# SITE DEVELOPMENT PLAN FOR SECURITY WATER DISTRICT WATER TREATMENT PLANT BUILDING ADDITION

EPC PCD FILE PPR262

**SWD PROPERTY SITE PLAN**  
WATER TREATMENT PLANT BUILDING ADDITION  
SECURITY WATER DISTRICT

**SITE GRADING, DRAINAGE, LANDSCAPING, AND EROSION CONTROL PLAN**  
WATER TREATMENT PLANT BUILDING ADDITION  
SECURITY WATER DISTRICT

**LANDSCAPE DETAILS**  
WATER TREATMENT PLANT BUILDING ADDITION  
SECURITY WATER DISTRICT

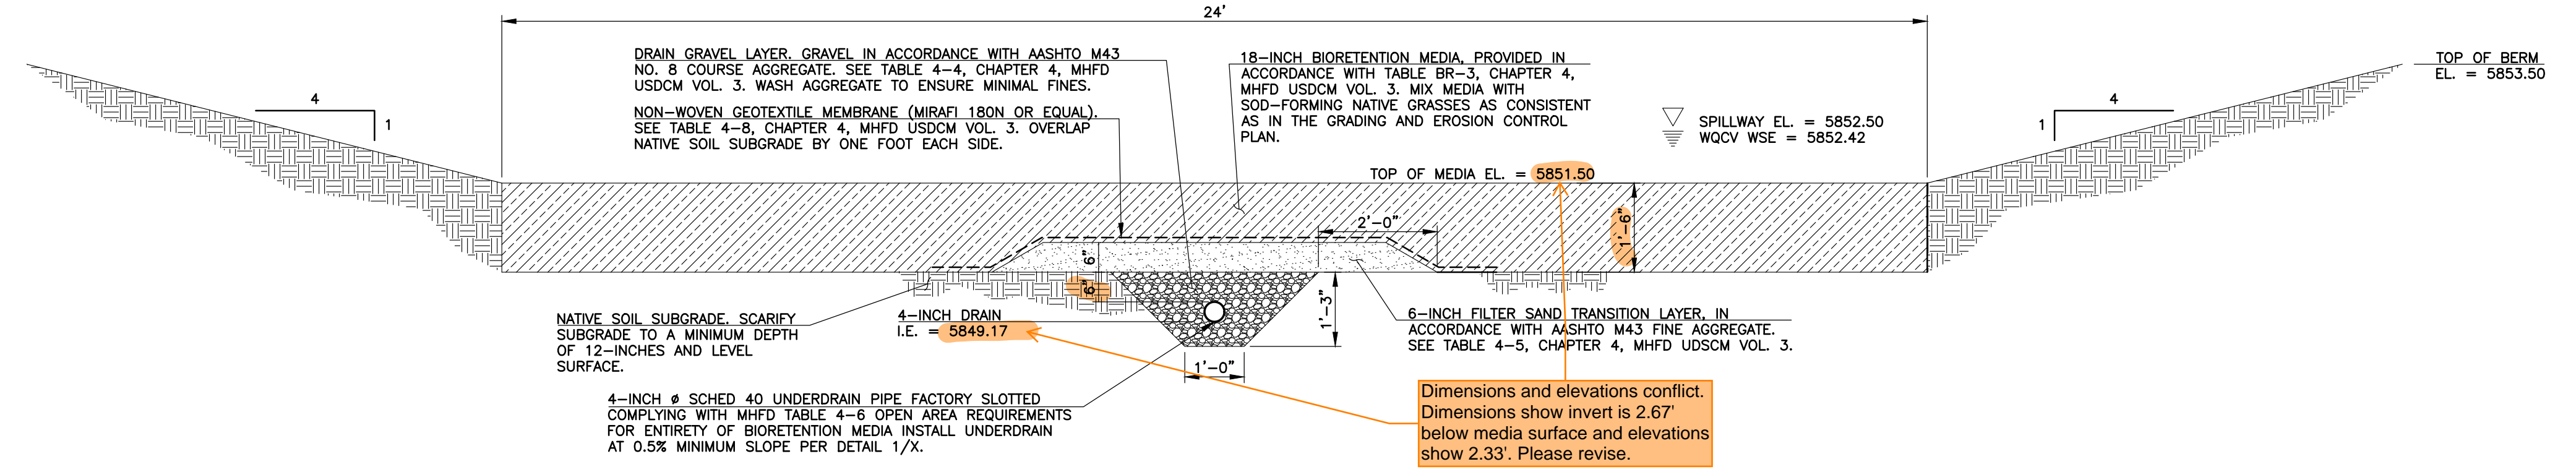
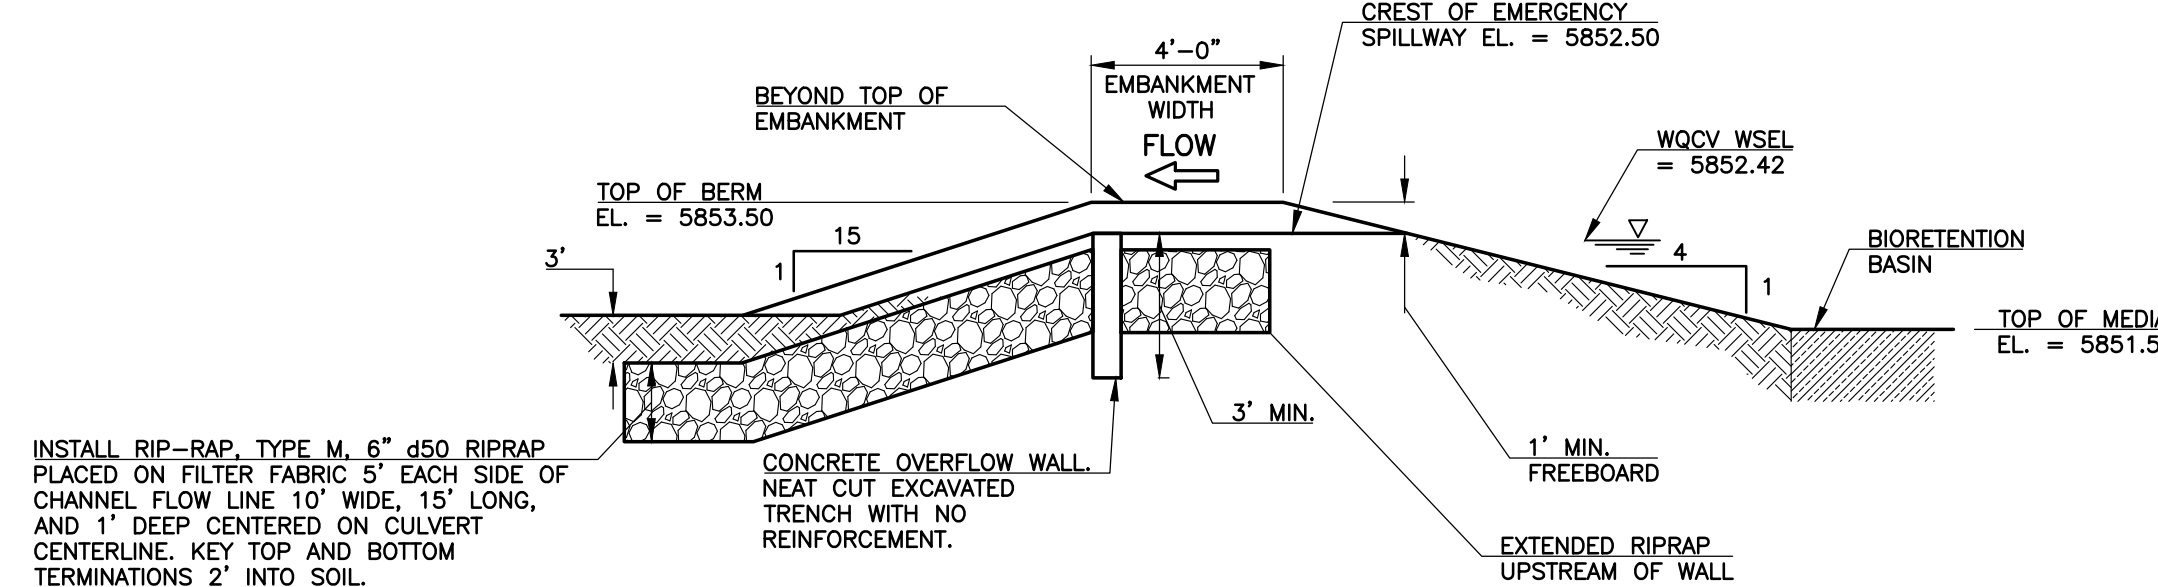
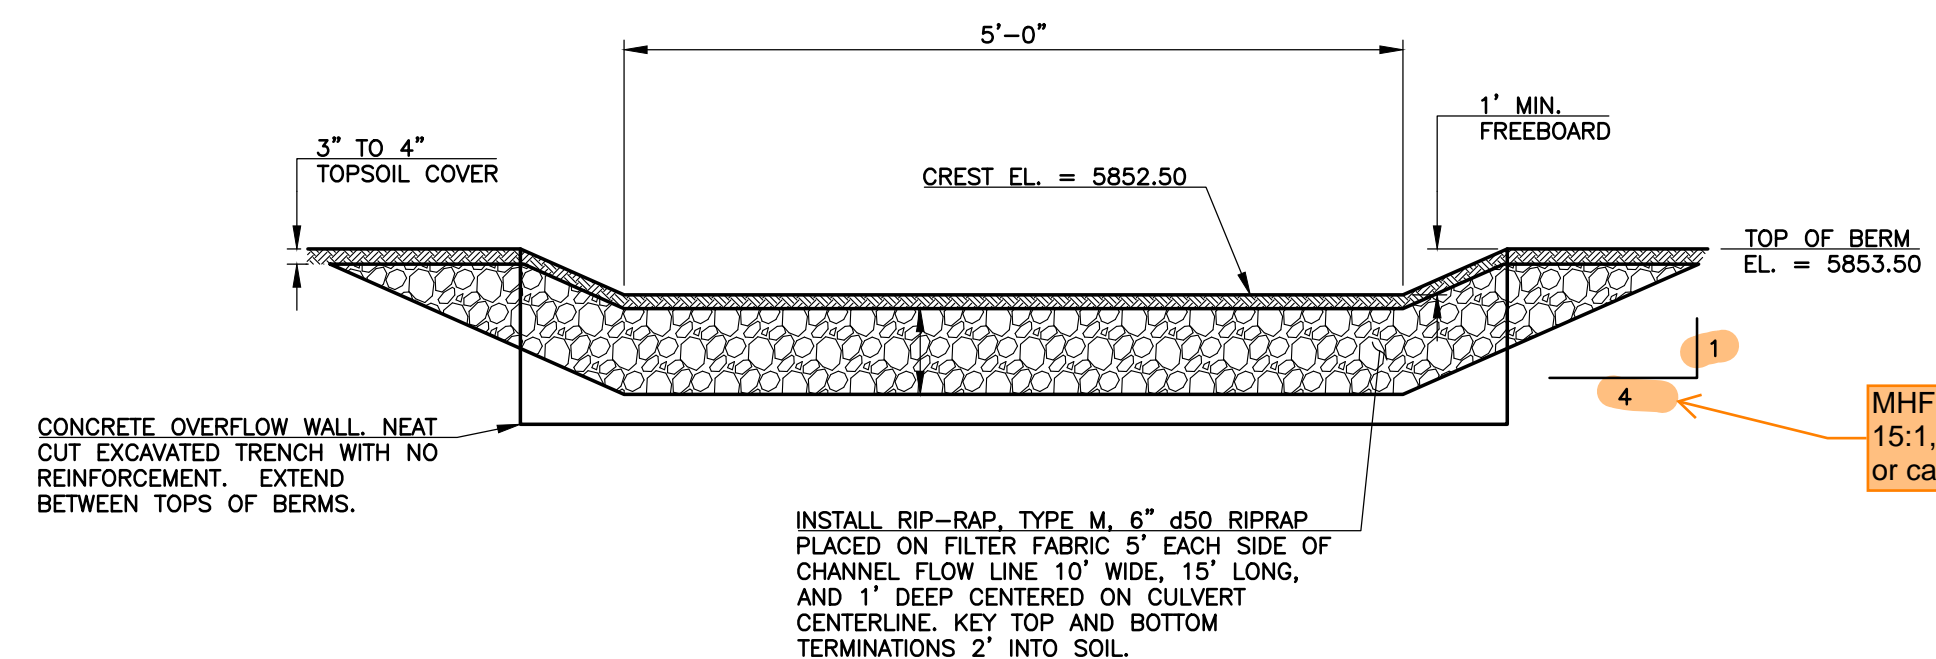
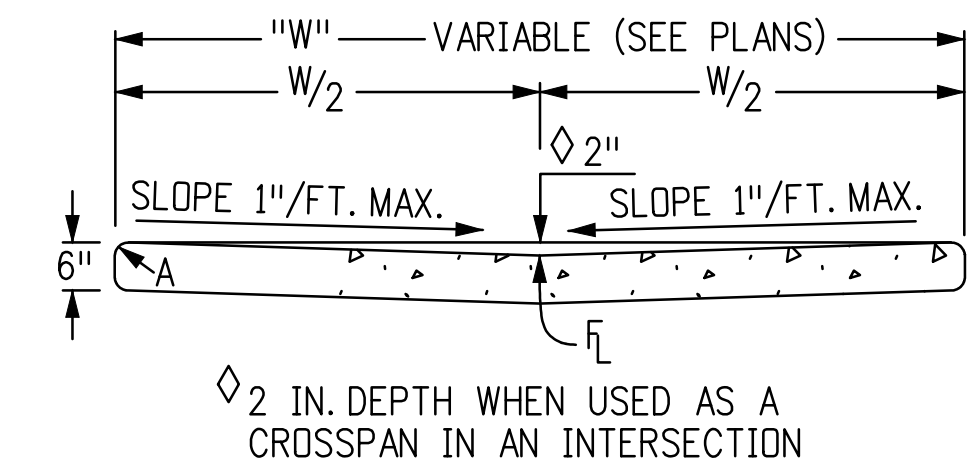
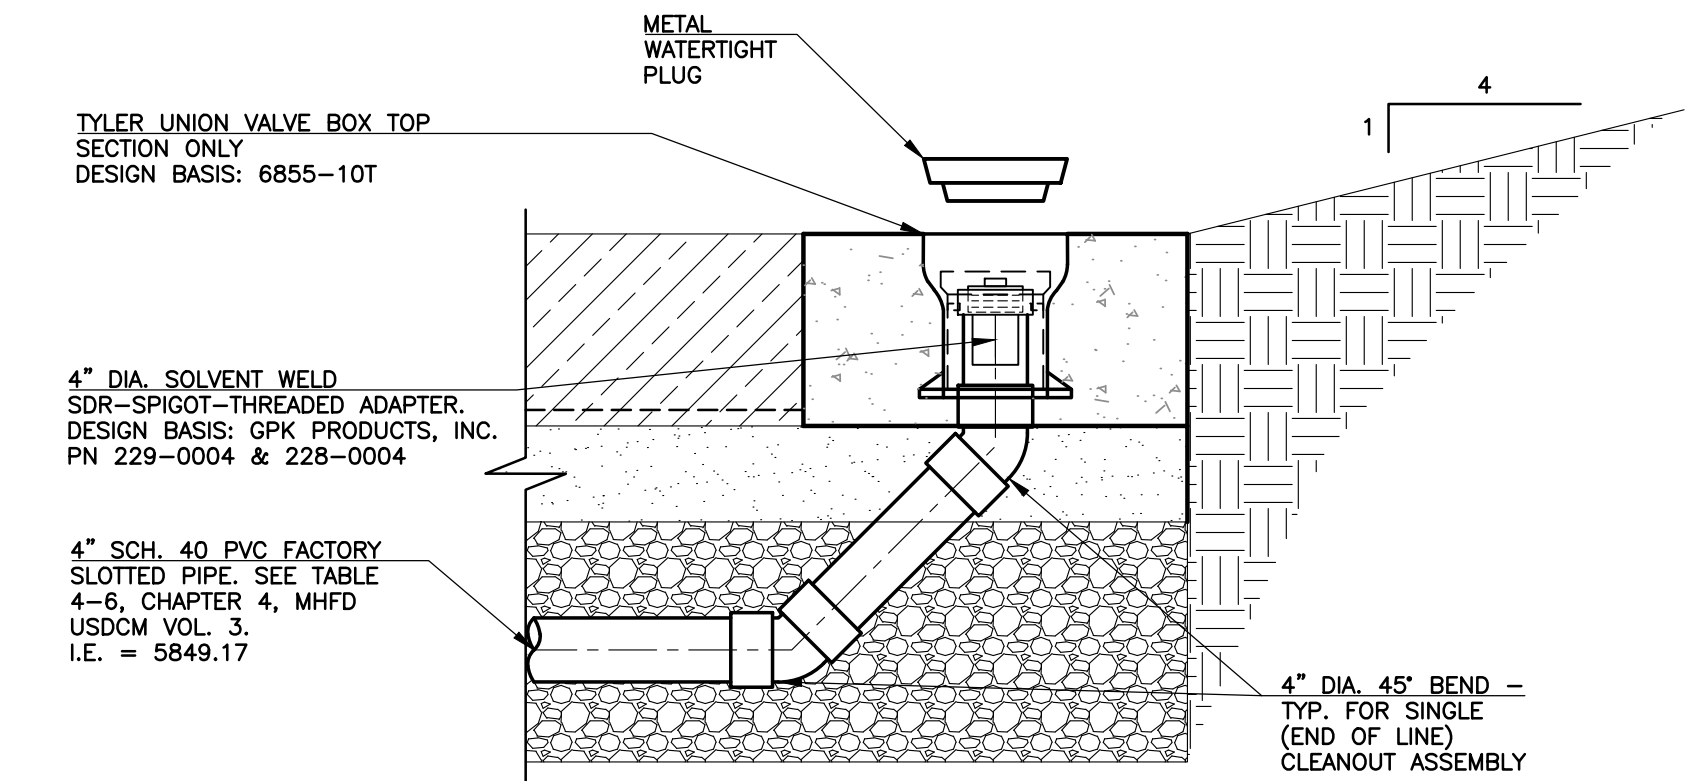
Please move these details to the GEC plan. The site development plan is approved by the EPC planning and community development department, not the department of public works (county engineer).
